TO: ALL BIDDERS

FROM: The Walker Group Architecture, Inc.

RE: Jones County Public Works

Jones County Public Works Building - REBID

E-101

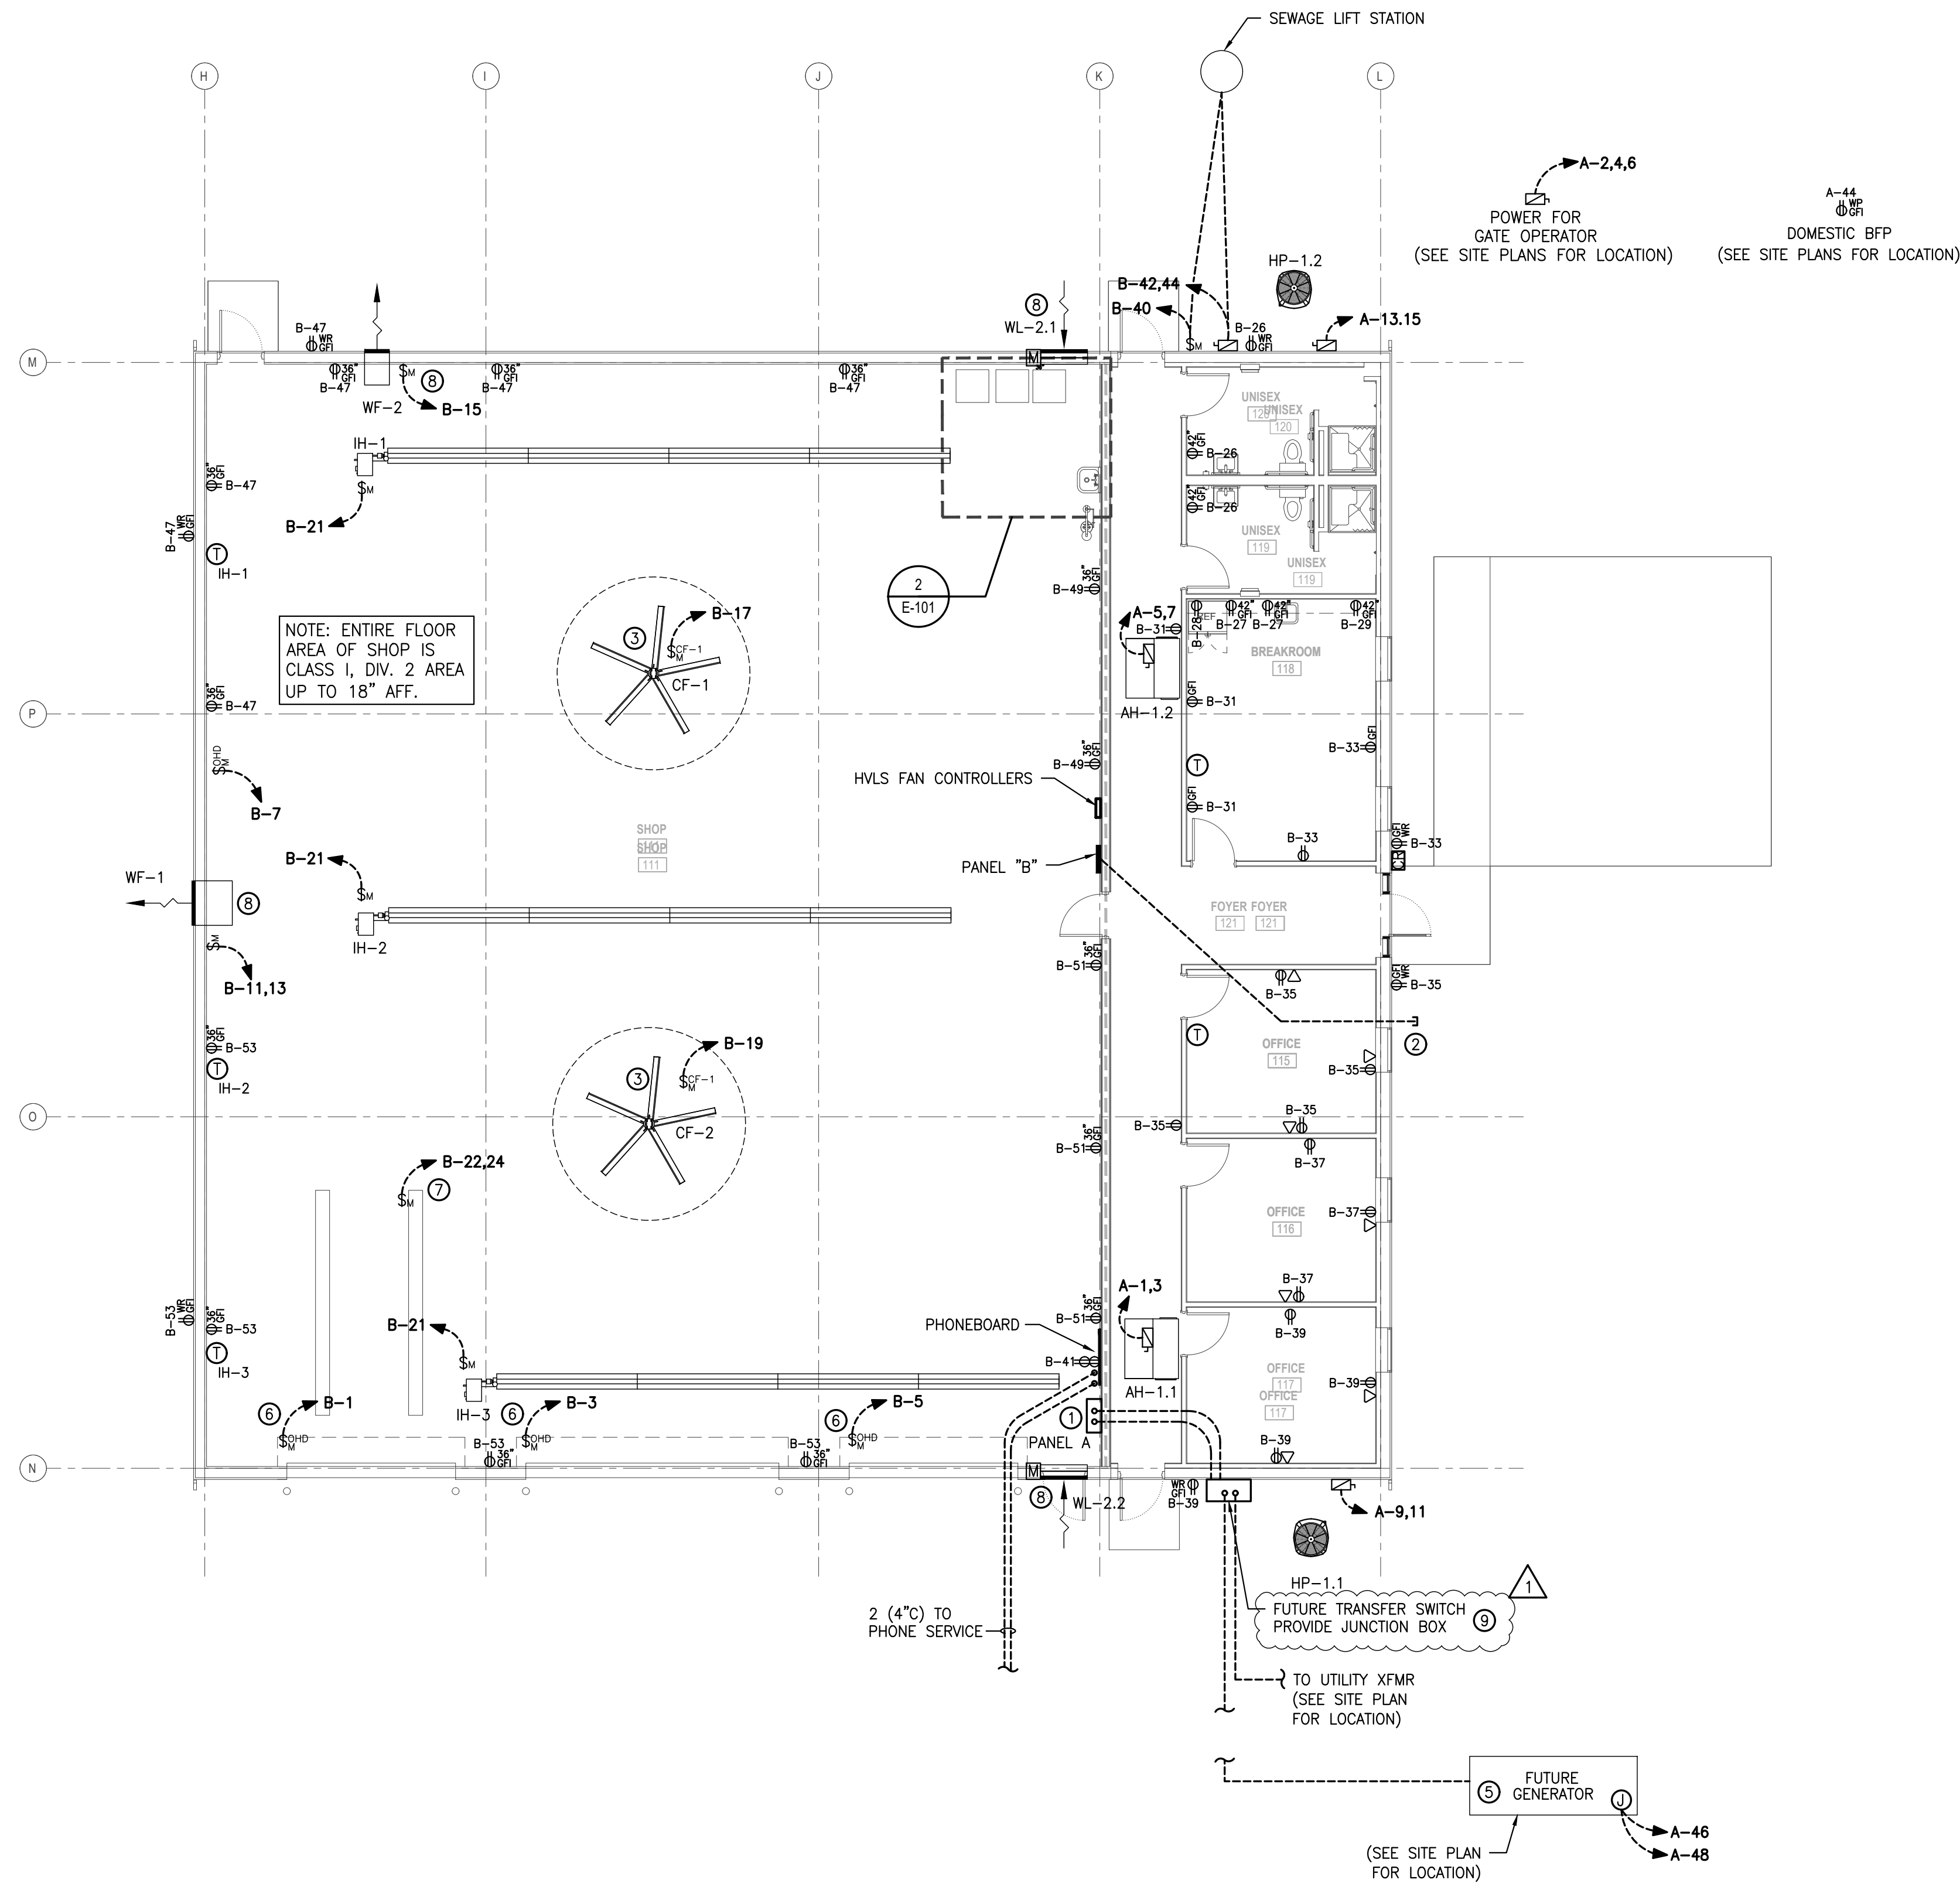
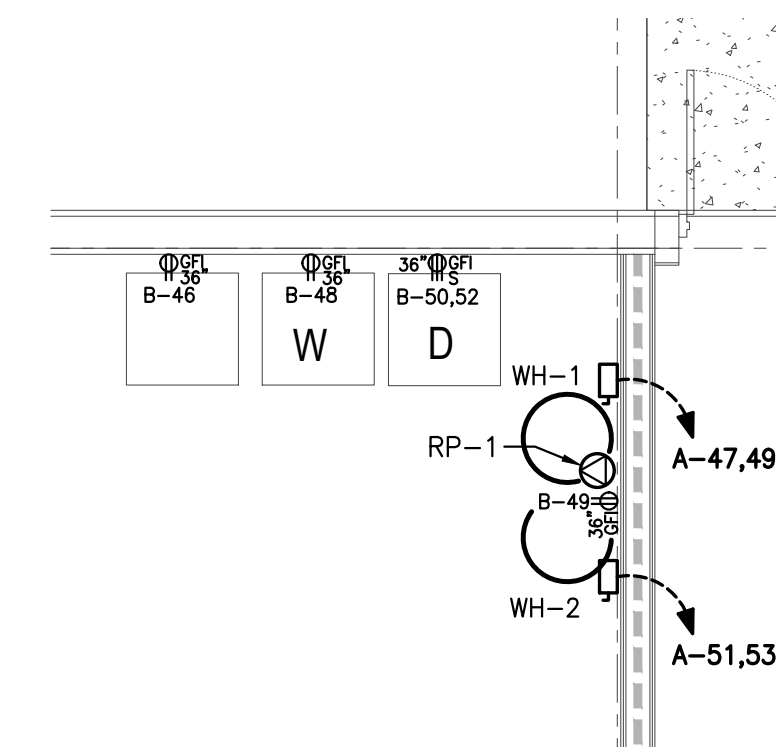
3. Page E101 States that the Generator and Transformer locations are on the Civil Drawings. We cannot find them on the Civil page. *Response: The generator has been removed. The transformer will be located by the utility company. Allow 100' for secondary conduit from transformer to building service point.*

7. Didn't the generator and transformer get removed? *Response: The generator is removed. Provide a conduit stub beside the building for future use. The transformer will be located by the utility company. Allow 100' for secondary conduit from transformer to building service point.*

32. Switch for the Generator still suppose to be on this or is it not. It is still on the prints and the Generator says for future and is suppose to be an alternate or does it all go away. *Response: The transfer switch and generator have both been removed from the project. There will be a junction box to allow for future installation of a switch.*

1. PROVIDE (3) SPARE 1" C FROM PANEL A TO EXTERIOR OF BUILDING. RACEWAYS SHALL BE ROUTED DOWN FROM PANEL AND INTO BUILDING SLAB, THROUGH FOOTING AND CAPPED UNDERGROUND. EXTEND 5- FEET BEYOND EDGE OF BUILDING.

2. PROVIDE (2) SPARE 2" C FROM PANEL B TO EXTERIOR OF BUILDING RACEWAYS. PROVIDE AS-BUILT PLANS SHOWING TERMINATION LOCATION OF RACEWAYS.
3. PROVIDE 1" C FROM CONTROLLER TO NEAR CEILING JOIST FOR CONTROL WIRING TO HVLS FAN (CF-1 AND CF-2). CAP POWER WIRING WITHIN JUNCTION BOX FOR FUTURE FANS.

4. PROVIDE RACEWAY & WIRING TO FUTURE OVERHEAD DOOR LOCATION.
5. PROVIDE EMPTY CONDUITS STUBBED OUT OF JUNCTION BOX AT FUTURE TRANSFER SWITCH LOCATION FOR FUTURE GENERATOR AND CAP UNDERGROUND.

7. LIFT IS FUTURE. INSTALL DISCONNECT AT CEILING.
8. PROVIDE 120V INTERLOCK WIRING FROM FAN TO ASSOCIATED LOUVER.
9. PROVIDE JUNCTION BOX AND RACEWAYS FOR FUTURE TRANSFER SWITCH. JUNCTION BOX AND WIRING SHALL BE INSTALLED SUCH THAT THERE IS ENOUGH CABLE SLACK IN THE BOX TO CUT AND TERMINATE TO NEW TRANSFER SWITCH.

E-301

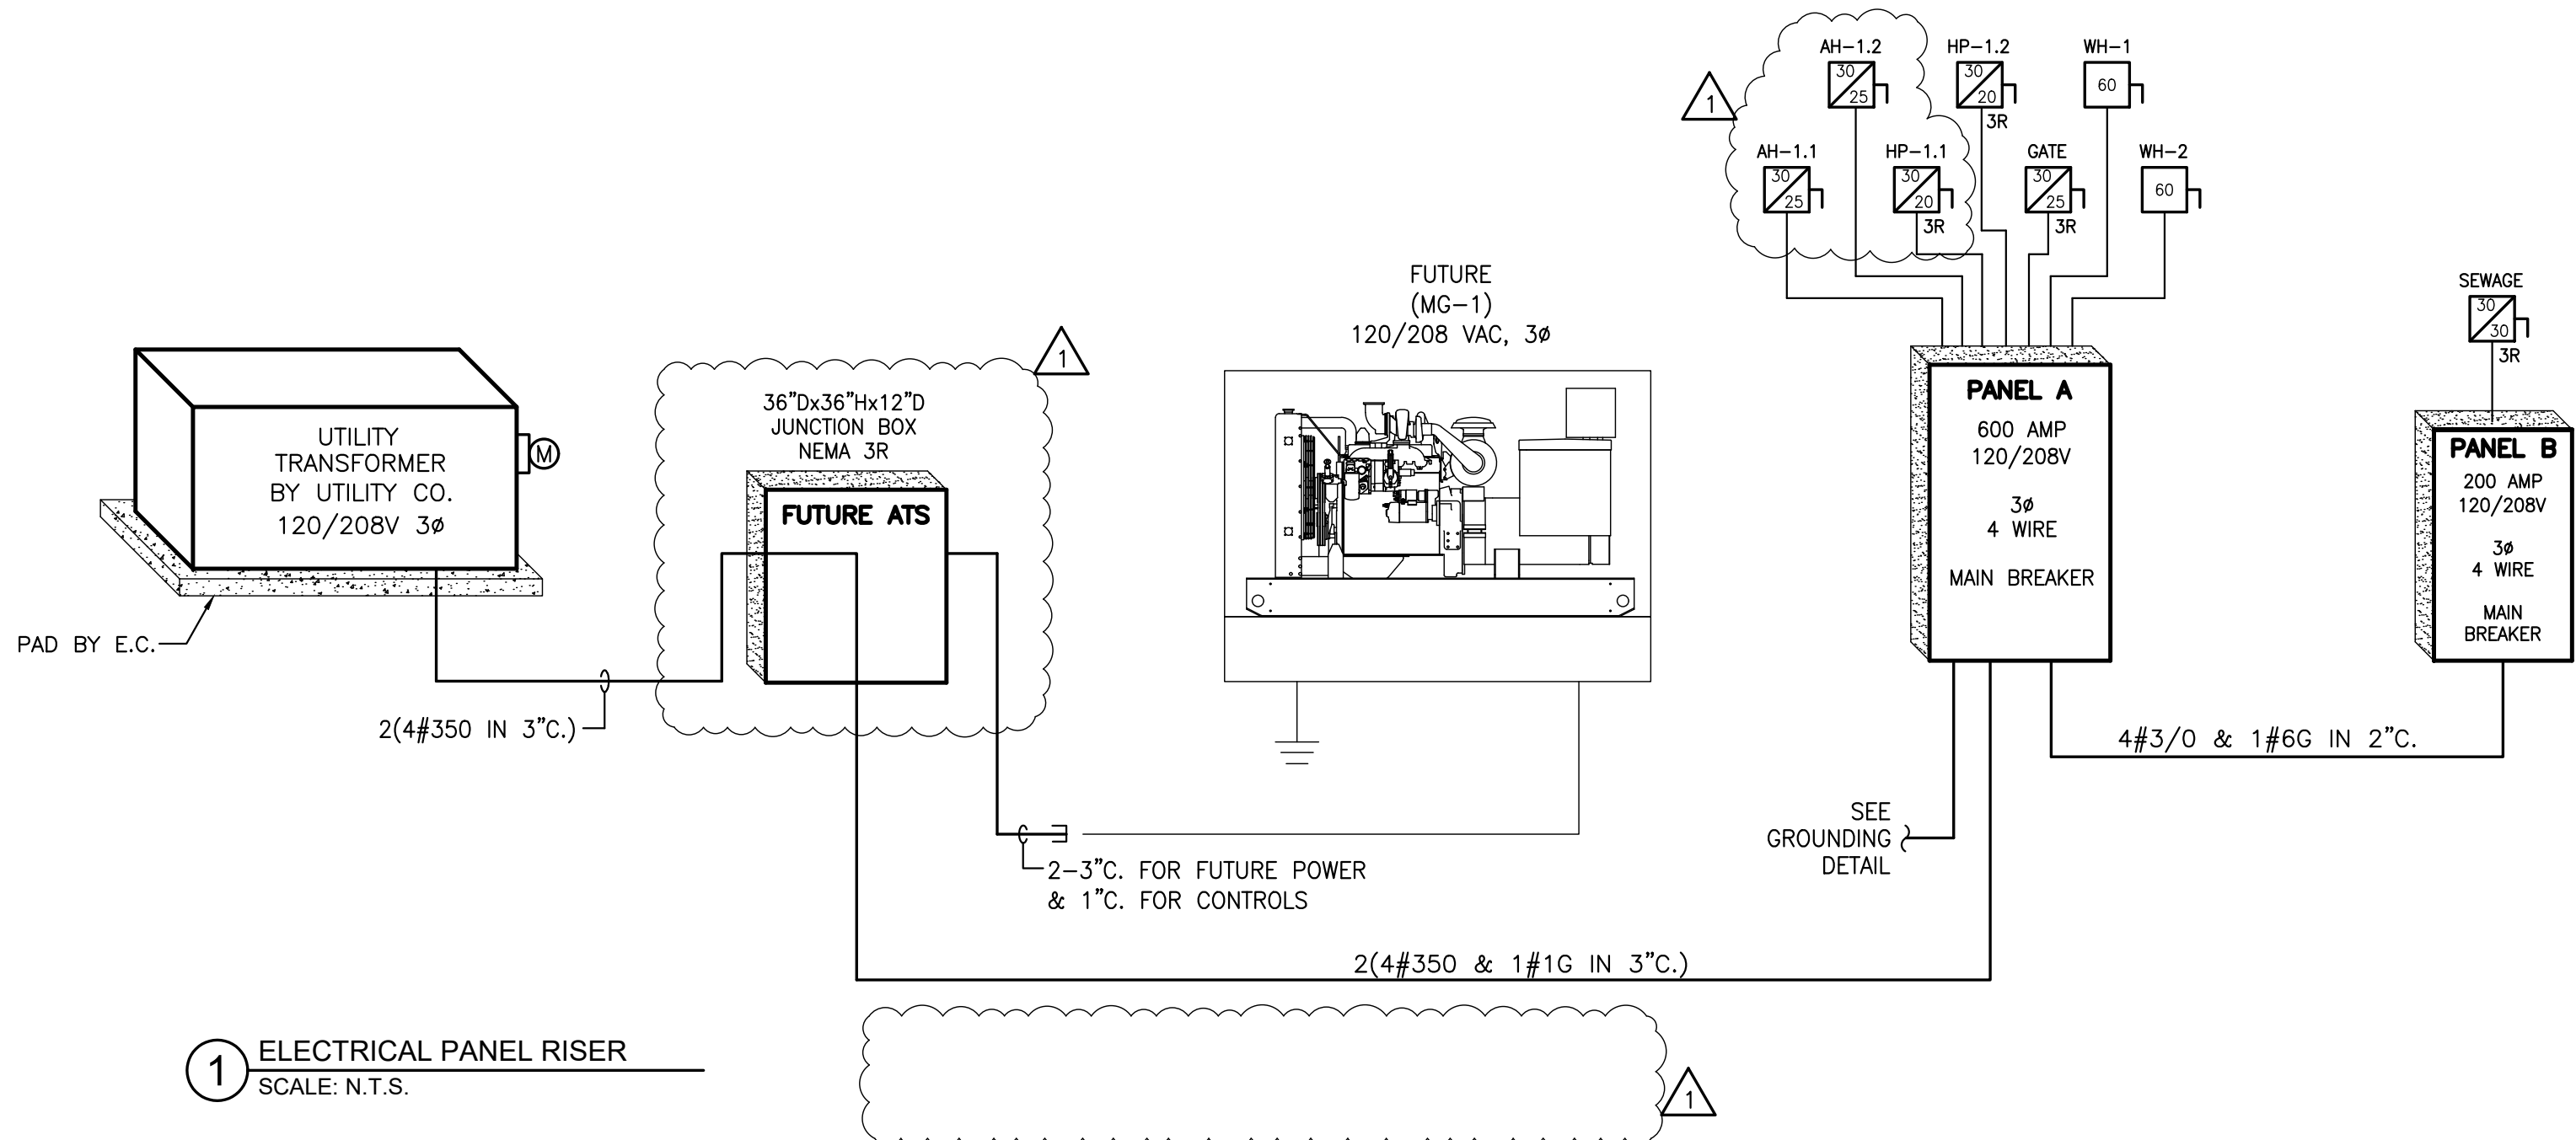
14. * Panel schedule legend seems to be very off such as the sub panel (B) breaker is shown to be three single pole breakers instead of what I would assume should be the 3 pole 200 amp breaker a few spaces above. Is that correct, and can we get a corrected schedule so that our supply house can put together the correct package ? Also if breakers are not being used are we installing spare single pole 20 amp breakers or are we putting breaker fillers in for future usage? *Response: Panel schedules have been updated with revised drawings.*

21. I am working on the Jones County Public Wors project and on E-301 the riser diagram shows AH-1.1 needing a 200A disconnect at the unit but the panel schedule shows it on a 25A breaker, AH-1.2 has a similar situation but with a 100A disconnect. Can you submit those questions to the architect to try and get some clarity on it? *Response: Please see revised drawings for corrections.*
